# **Completeness Review Response**

## **Re: 24-105597-PLN**

## **Stormwater Management System**

Single-Family Residential within Commercial Zoning  
2886,2888,2890 Brooks Ave NE, Salem, OR 97301  
Three Parcel Partition

# PROPOSED LAND PARTITION (OPTION 2) 2886 BROOKS AVE NE

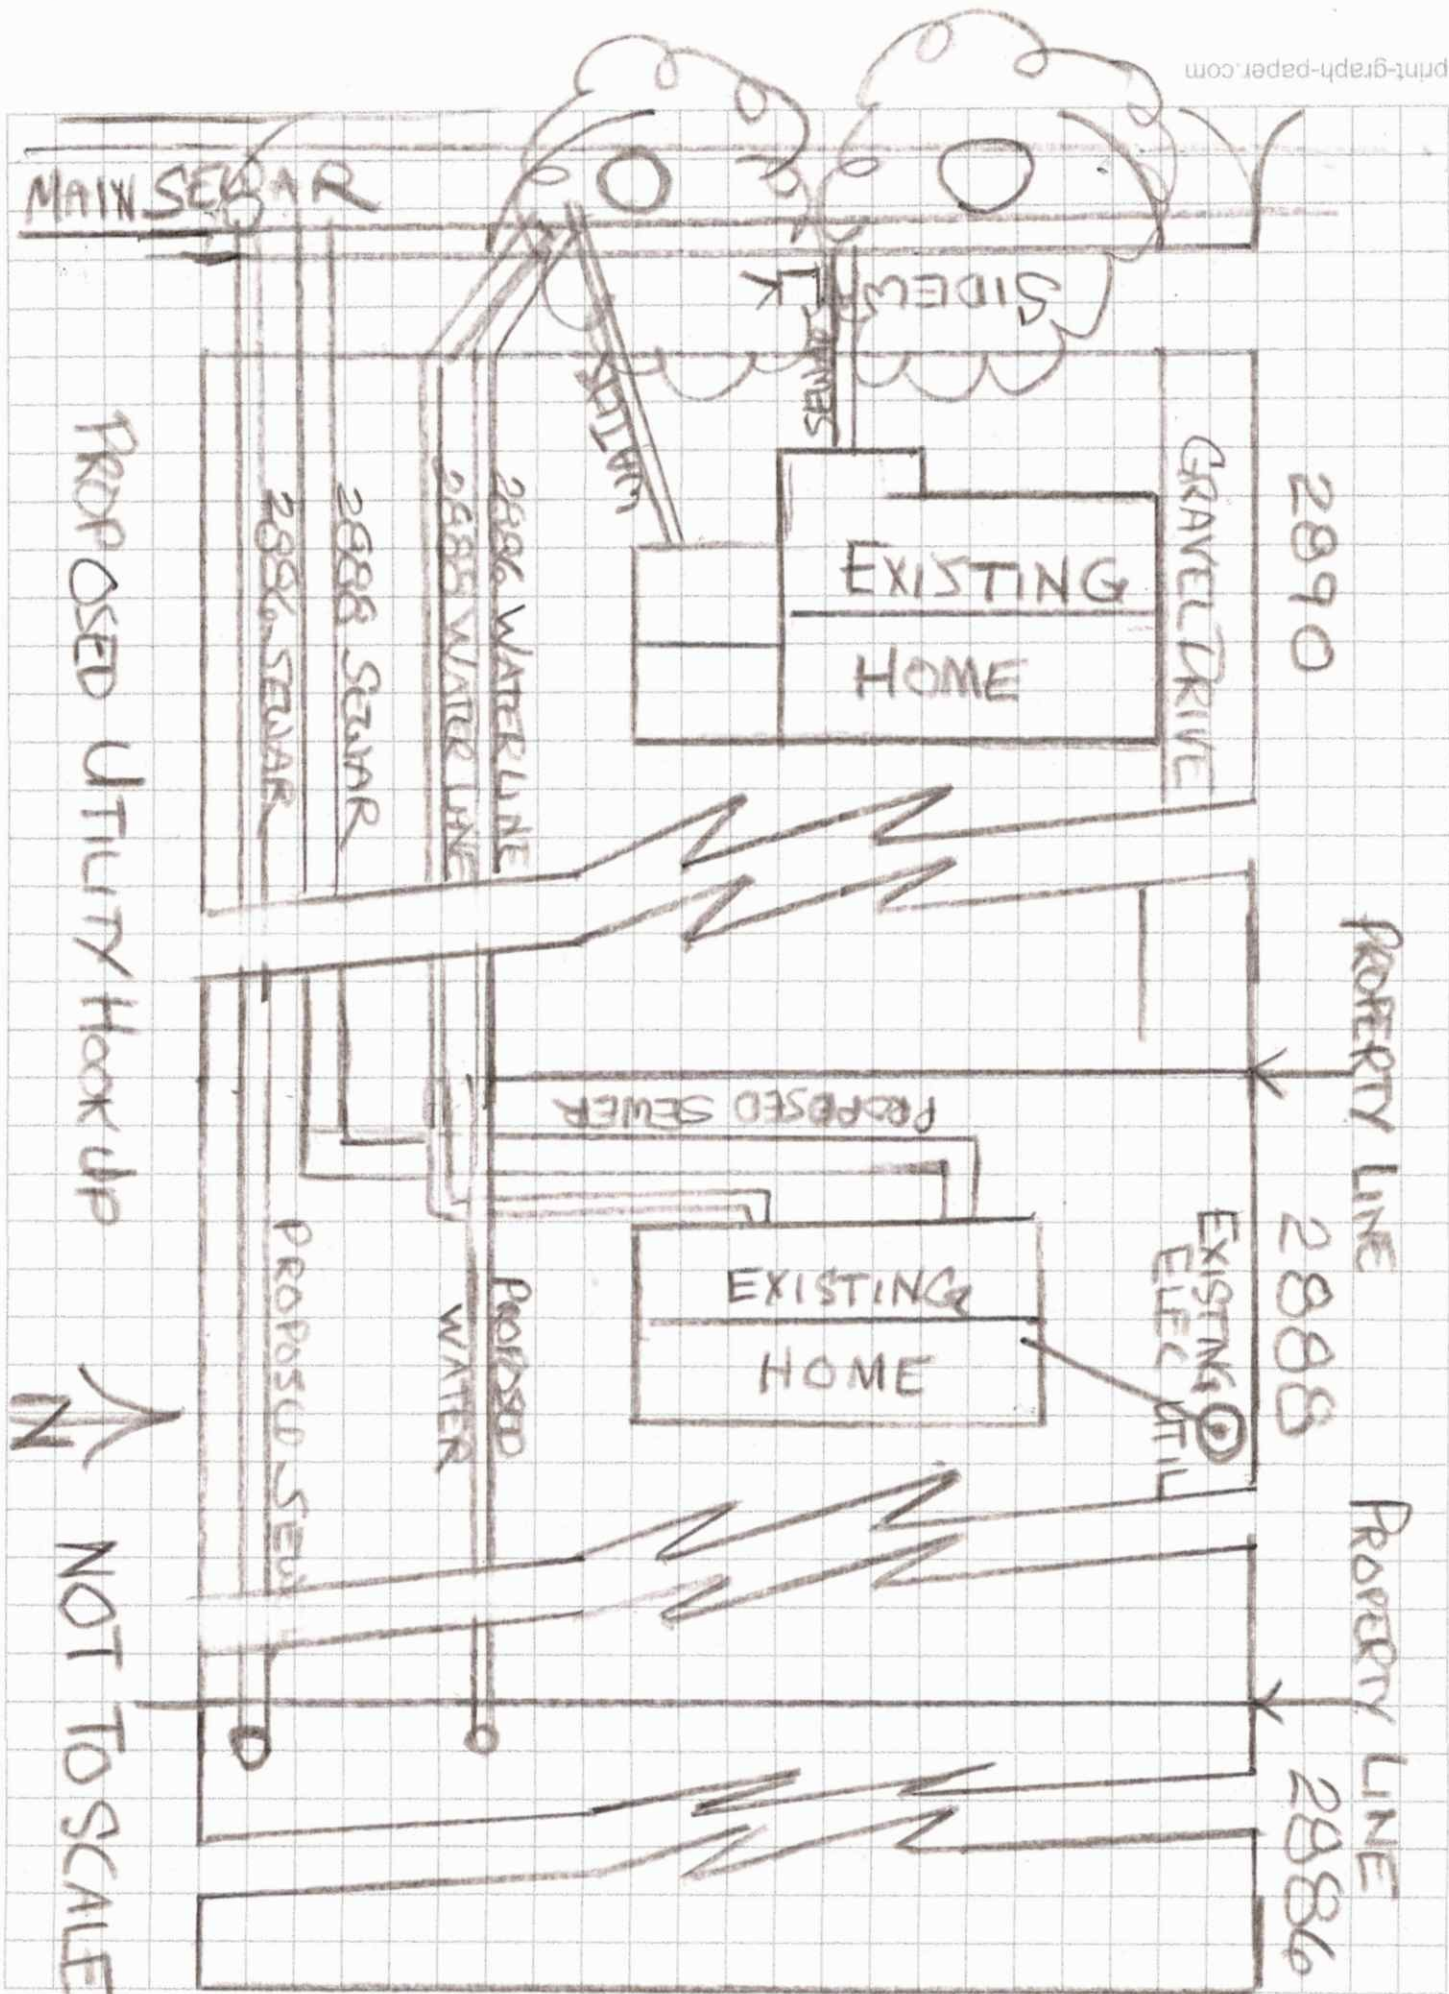
**Flag Lot length;** The flag lot length and width meet the requirements but the length of the Driveway exceeds the 150' limit by 27' with reason due to the unknown of a future home on portion #3. The additional area falls in line with the planned Rain Garden which with approval can become a permeable paved parking or reversing area with an Overflow Basin. Options are open to later determinations should a home be built in that lot.

**Note;** It is at this point that I state that I do not wish to reconfigure the lots due to the convenient location of the Rain Garden acting as both a way of handling excess stormwater without runoff to the streets and as a natural fence between properties.

# STORM WATER PROPOSAL

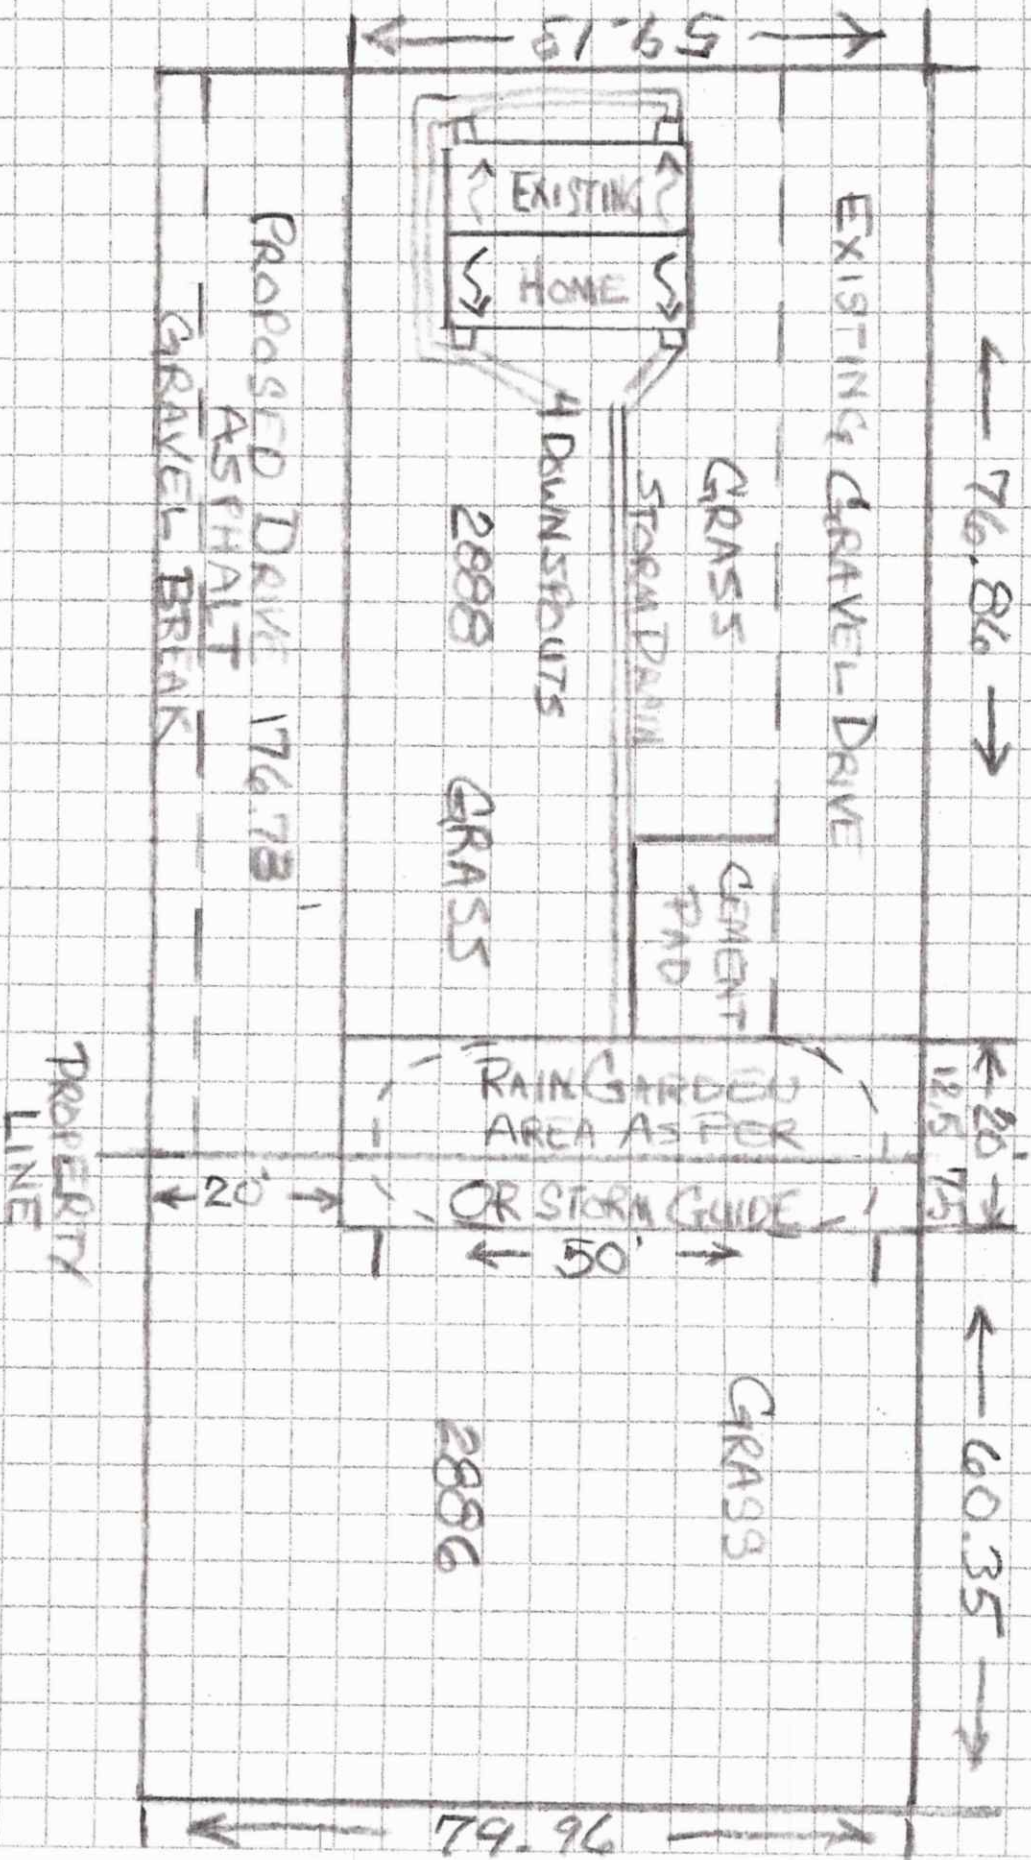
**Parcel #2.** Parcel Two, also known as 2888 Brooks Ave NE, is tentatively platted at 5278sf, which includes the existing single family home that was previously connected to both sewer and water from the Parcel One home also known as 2890 Brooks Ave NE and has always been hooked to Salem Electric separately, this home is 418sqf and with approximately 815sqf which includes a 216sqf cement slab of impervious area and is ready for water and sewer hookup to complete the partition. This Parcel with home is sitting level with less than 1% grade on an all grass lawn with no ponding or runoff observed over the last 13 years and has a perforated pipe completely encircling the home and previously attached to the stormwater/sewer of Parcel #1. The gutters drains are presently running off to the lawn both east and west. The parcel access is intended to be a 150' X 20' driveway that has direct access to Brooks Ave NE running east to west with a remaining 20' X 27' driveway that is intended to be a possible basin drain area to mitigate the overflow of a Rain Garden or specifically the proposed driveway.

Then if necessary, the covered basin overflow with a 3" sched 40 PVC drain pipe running to the curb for overflow drainage at the Brooks Ave Street, then the runoff will flow down to the Brooks Ave and McDonald St Storm Drain. The Rain Garden between both Parcel #2 and Parcel #3 as outlined in Salem OR Public Works Plan 217 with an extension of the 20' X 27' Permeable Driveway running in line to the proposed drive to the North creating an additional 20' X 59' Rain Garden or Permeable Driveway all being preferred as a Permeable Driveway. It should be possible with the additional 27' X 20' of Permeable Driveway the overflow that could exist may be handled within the property itself as it has since the beginning.

**Parcel #3.** Parcel Three, also known as 2886 Brooks Ave NE. is tentatively platted at 5,278sf, has no existing home and is sitting level with no impervious area and with less than 1% grade to the West it also has 100% lawn with no pooling or runoff observed over the last 13 years and will be separated from Parcel #2 to provide an accessible and buildable lot. The lot has access to Brooks Ave NE Through the 150' x 20' easement and by the 27' x 20' Rain Garden/Permeable driveway and if necessary with the covered basin overflow that is drained with a 3" sched 40 pvc pipe that exits at the curb on Brooks Ave NE
